GOVERNMENT OF INDIA
MINISTRY OF ENVIRONMENT & FORESTS
Central Zoo Authority

F. No. 19-58/93-CZA(190)(Vol. III)(M)/1780

Sub:- Designs for the construction of Leopard and Bear enclosure at Manipur Zoological Garden, Imphal and Master (layout) Plan of the Zoo.

The designs for the construction of Leopard and Bear enclosure at Manipur Zoological Garden, Imphal and Master (layout) Plan of the Zoo were placed before the Expert Group of Zoo Designing Meeting held on 20th September 2012. The members scrutinized the designs and Master (layout) Plan and following observations were made:-

PLAN Scale 1:100

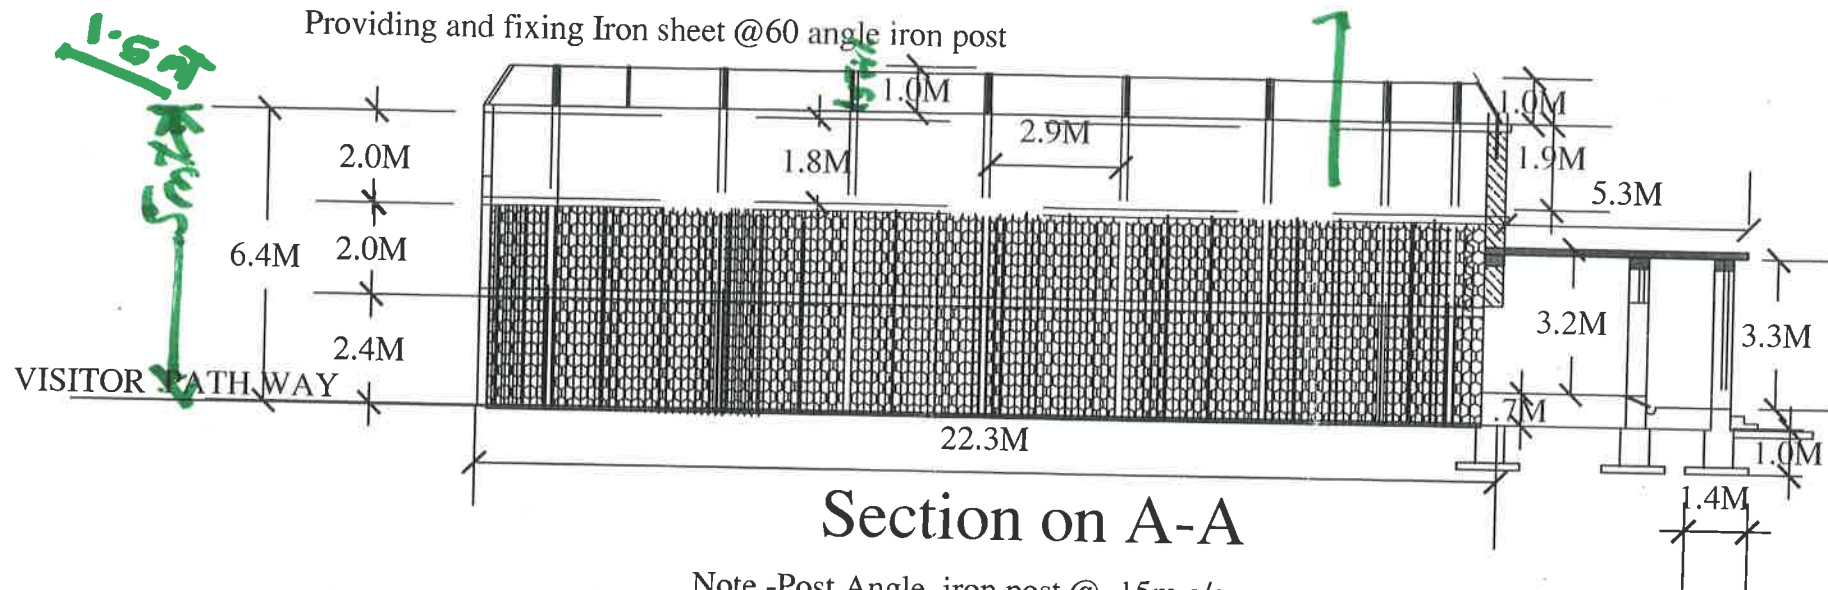
(i) **Construction of Leopard enclosure**

The design was scrutinized and approved subject to the following conditions:-

- There should be four feeding and retiring cells.
- The kraal should be shifted away from the visitor's area.
- The total height of the vertical fence should be kept 5 mt. and overhang should be at 60 degree angle of 1.5 meter wide.
- The overhang should use the MS sheet only instead of chain-link fence.
- No iron plate should be used on vertical fence.
- The chain-link fence should be fixed on the inner side of the fence.
- The chain-link fence should be of 5cm x 5cm x 10 gauge.
